SB-0001 Orion VII/NG Li-Ion ESS Mitigation Measures

Bulletin Number:	SB-0001	Revision:	A	EIC Number:	N/A	Std. Repair Time:	N/A
Application:	Orion VII and Orion VII NG model hybrid buses with Li-Ion Energy Storage Systems.						
Classification:							
Information Letter	<input checked="" type="checkbox"/>	Parts Bulletin	<input type="checkbox"/>	Service Manual Update	<input type="checkbox"/>	Operator's Manual Update	<input type="checkbox"/>

Figure 1-1

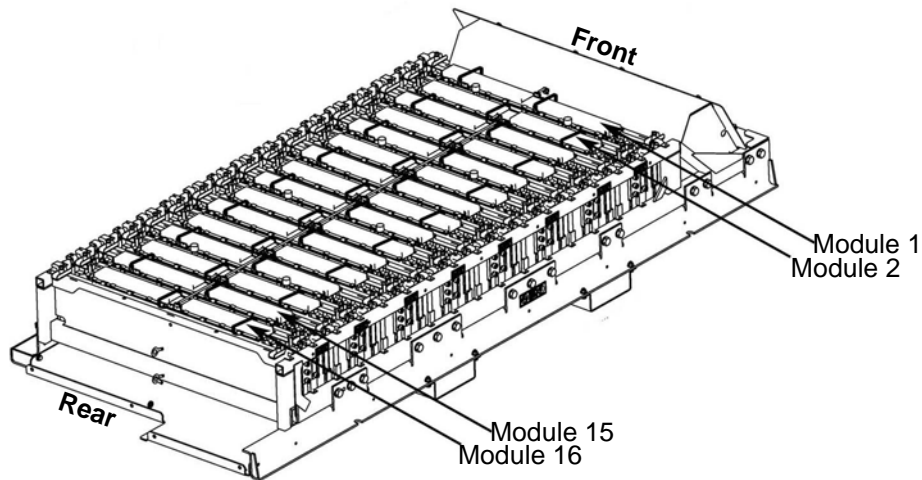
- a. Remove modules 1, 2, 15, and 16 (**see Figure 1-1**) to clean the ESS frame module support rails.
 - b. Clean the bottom surface of each of the removed modules.
2. Maintenance personnel should monitor the CHECK HEV light on the driver's front dash panel. If illuminated, check for active fault(s).
